This is to notify you that Littelfuse will change the Tube packing quantity for Thyristor TO-220(Isolated and Non-Isolated) and TO-263(D<sup>2</sup>-PAK) products from 500pcs/box to 1000pcs/box. Detail affected part number list refer to attachment.

# PCN Report

**Prepared By** : Lei Wu, Product Engineer  
**Date** : April 20<sup>th</sup>, 2020  
**Device** : Thyristor TO-220/TO-263 Tube packing Product Series  
**Revision** : B

## 3.0 Packing Method:

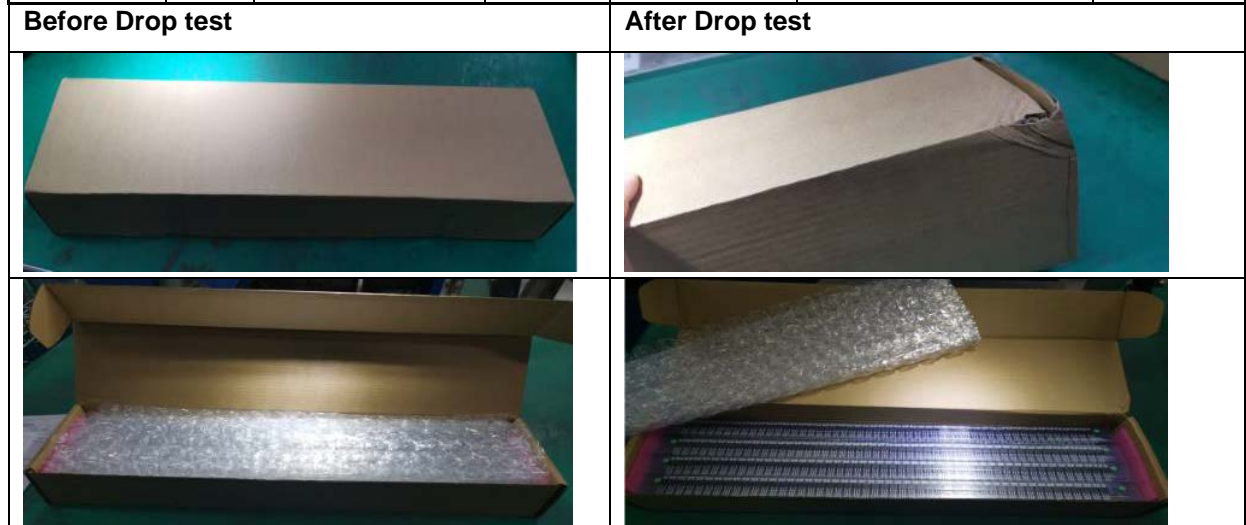
Tube packing quantity will be changed, change it from 500pcs/box to 1000pcs/Box.

### 6.0 Electrical Characteristic Summary:

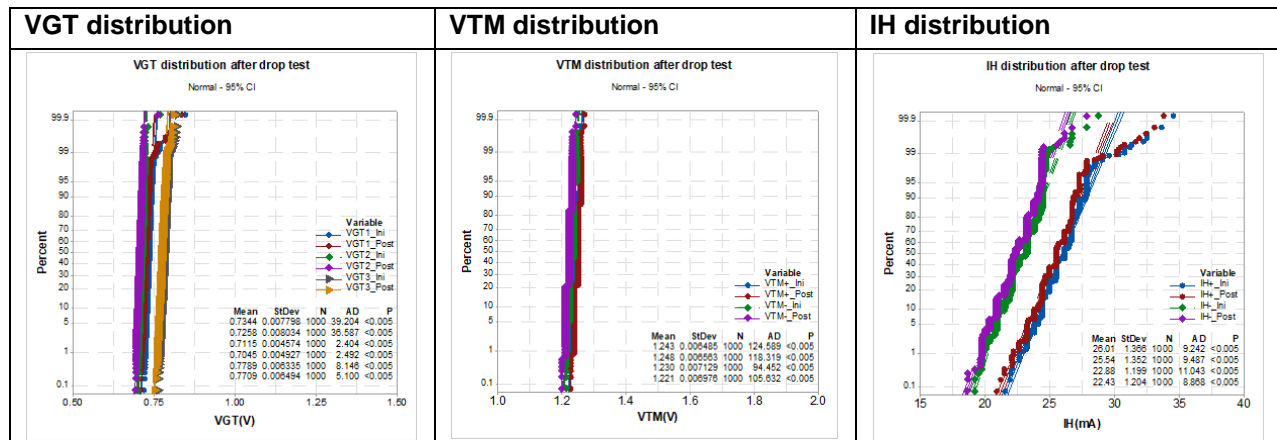
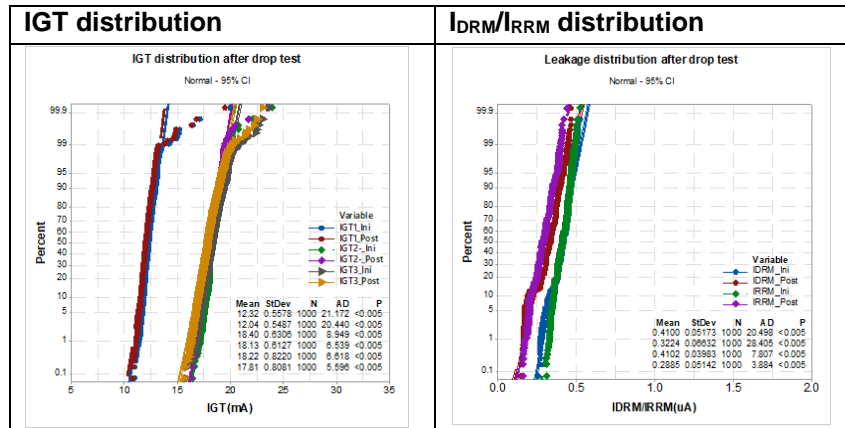
There is no change in electrical characteristics after drop test.
